# 145 kV CAPACITOR VOLTAGE TRANSFORMER TYPE: CPB-H 145

END CUSTOMER:  
APTRANSCO

<b>LIST OF DOCUMENTS FOR CPB-H 145 TYPE CVT</b>	Scale NTS
	T.Sh. 1
	Sheets 1

**6096769/2022/EEMRT-ENE51** **GUARANTEED TECHNICAL PARTICULARS**  
**FOR 132kV CAPACITOR VOLTAGE TRANSFORMERS**

General Arrangement Drawing

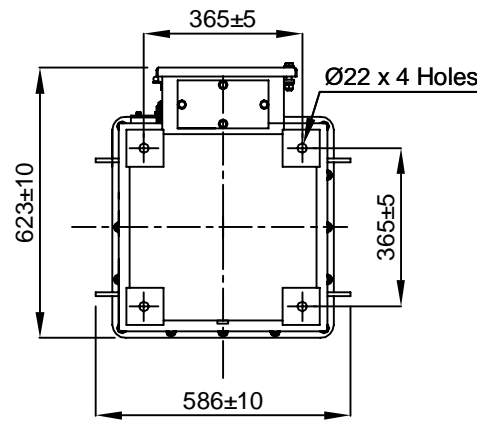
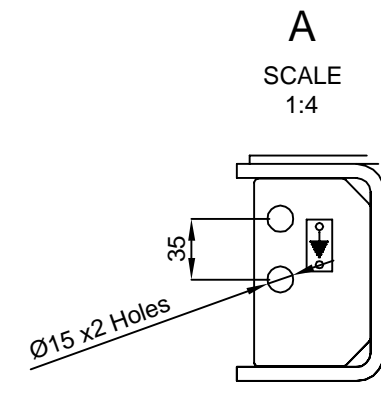
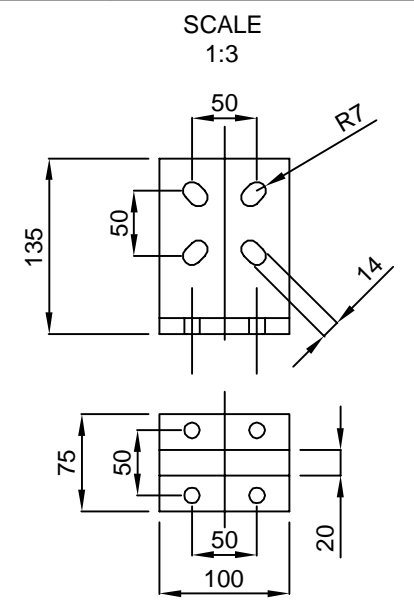
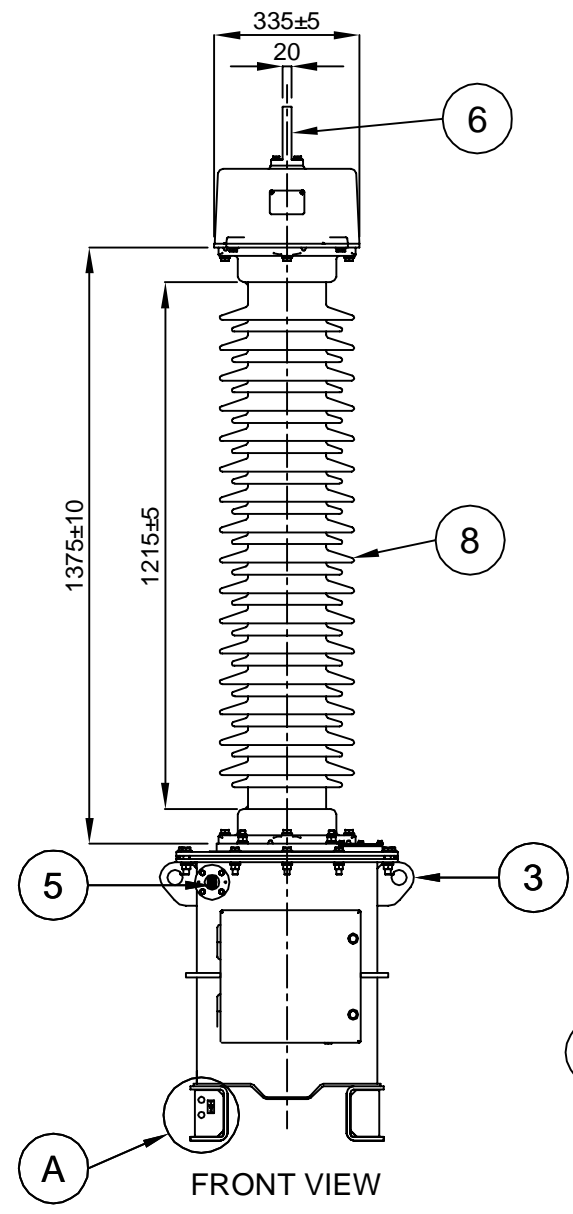
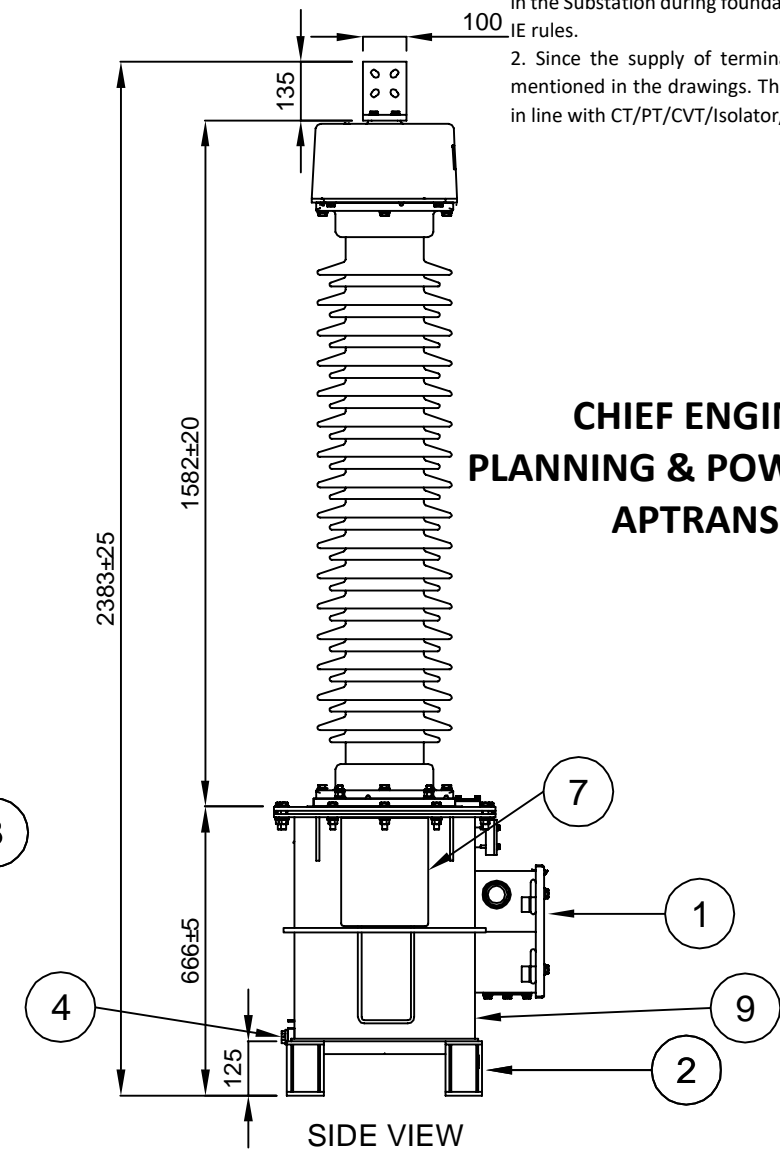
1. Minimum 300mm plinth shall be maintained for CT/PT/CVT/Isolators/IV/LA/Breakers in the Substation during foundation works to ensure safe live to ground clearance as per IE rules.
2. Since the supply of terminal connectors is not in the scope of manufacturer as mentioned in the drawings. The EPC contractor shall be instructed to supply the same in line with CT/PT/CVT/Isolator/IVT/LA/Breakers requirement and compatibility.
